REMARKS

Amendments to the Drawings:

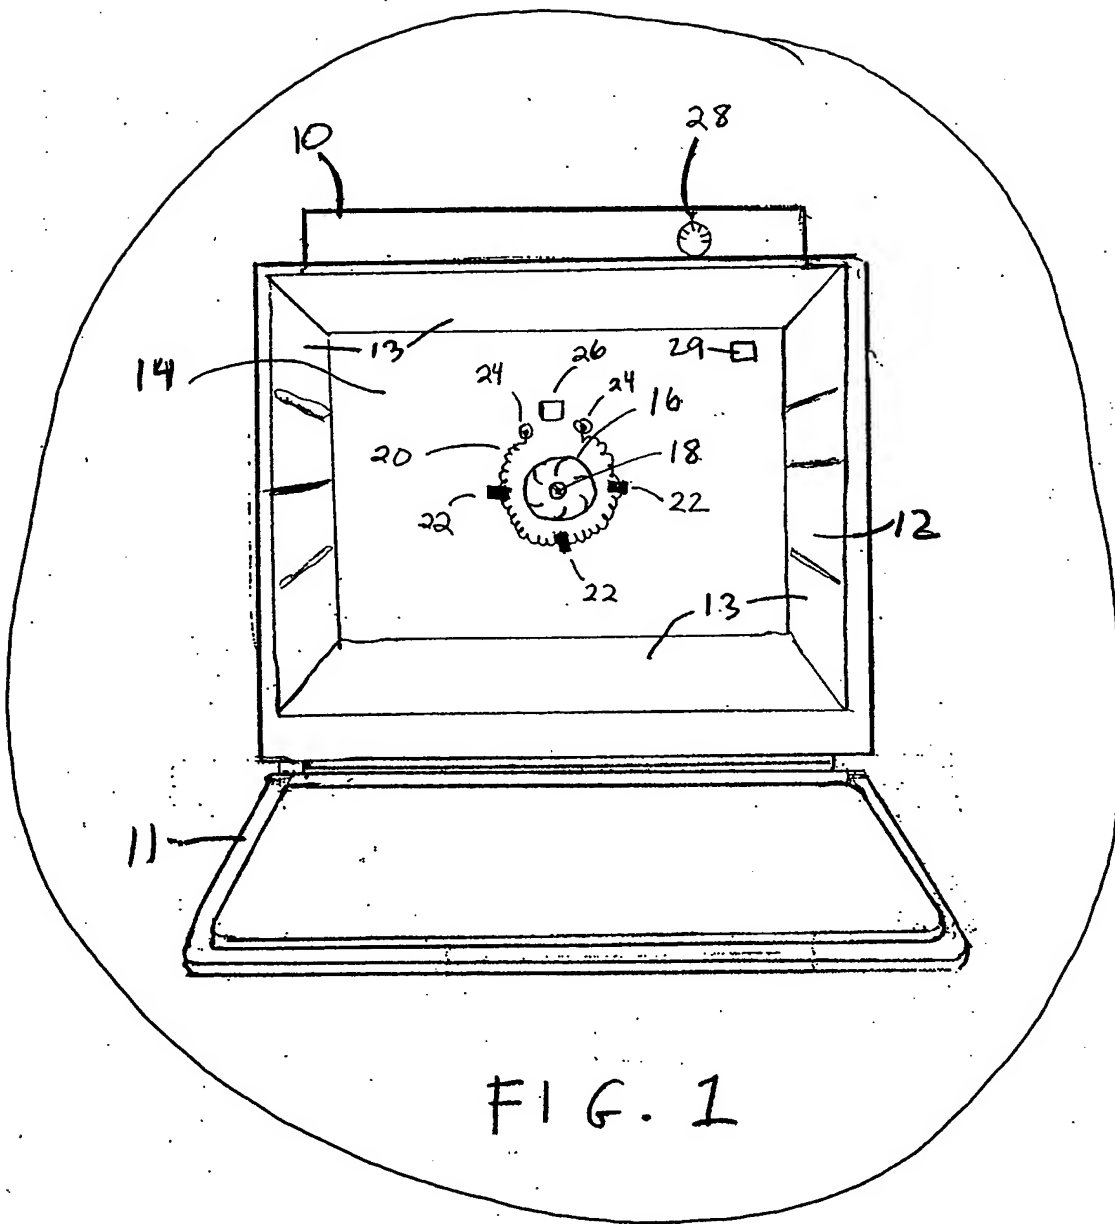
The specific changes which have been made to the new formal drawing Figure 1 are to clean up and clarify the front view of a convection oven with the oven door open (to show an exemplary open coil heating element according to the invention) that was shown in the Figure 1 previously submitted.

Fig. 2

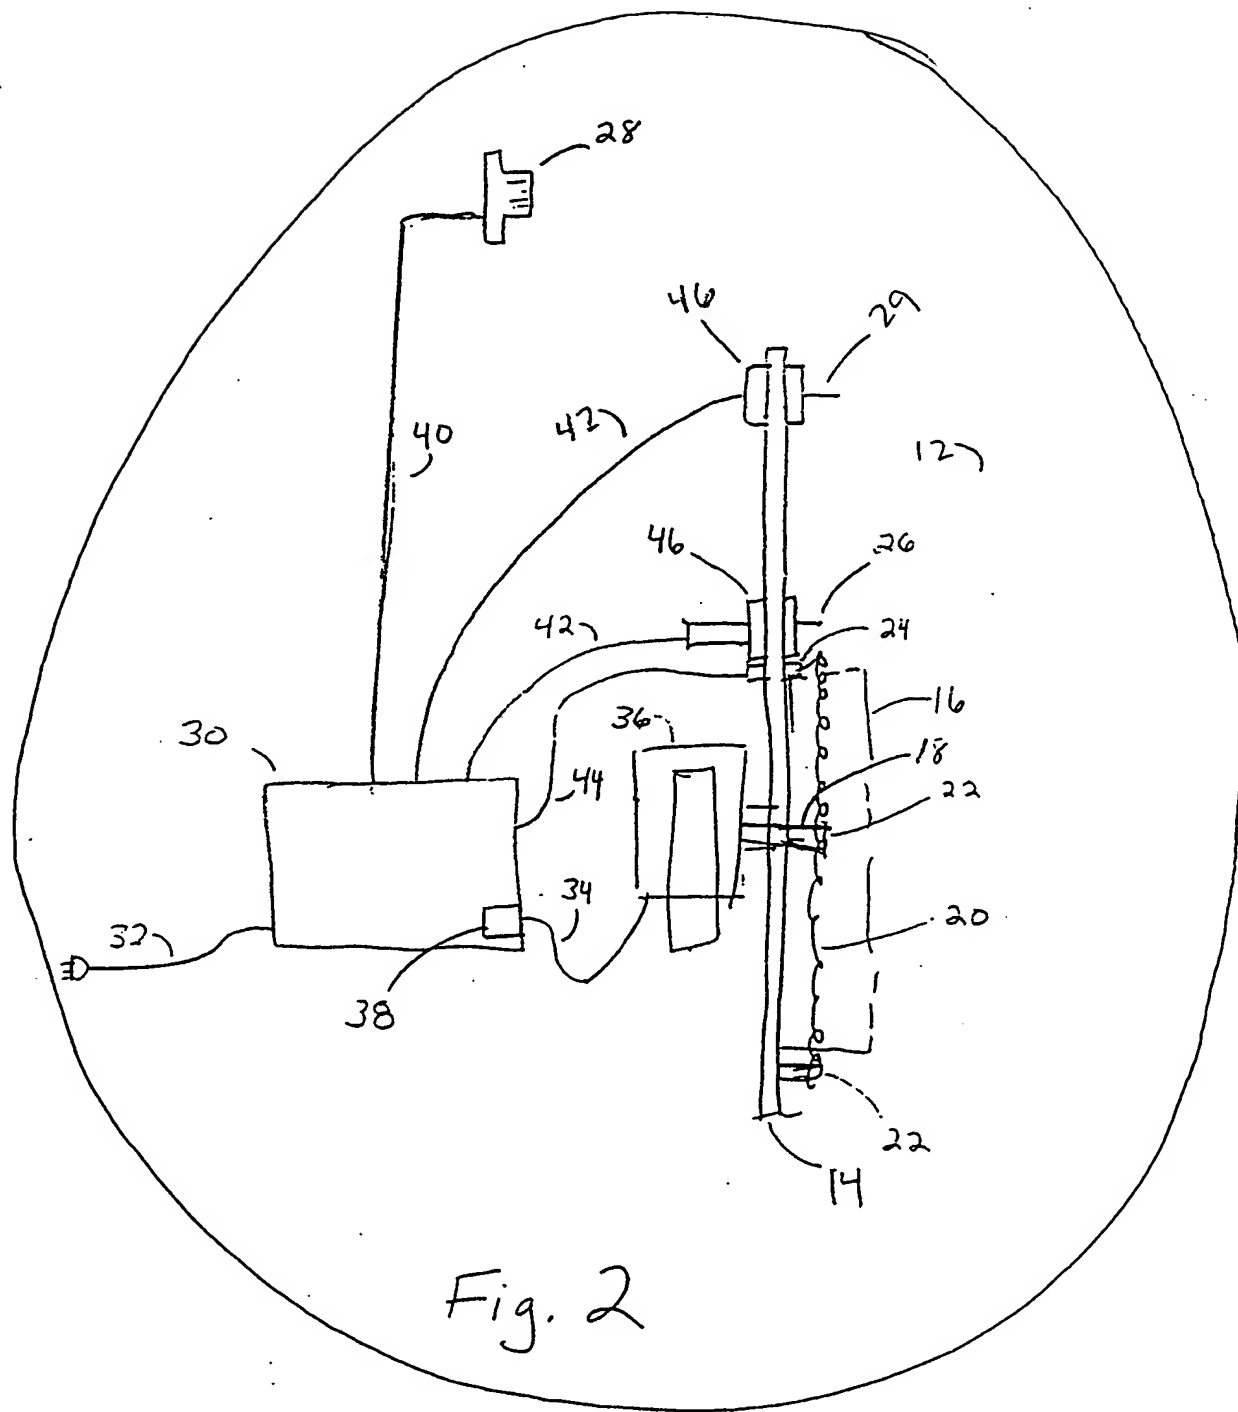
The specific changes which have been made to the new formal drawing Figure 2 are to clean up and clarify the schematic side view block diagram of an exemplary open coil heating element and fan according to the invention that was shown in the Figure 2 previously submitted.
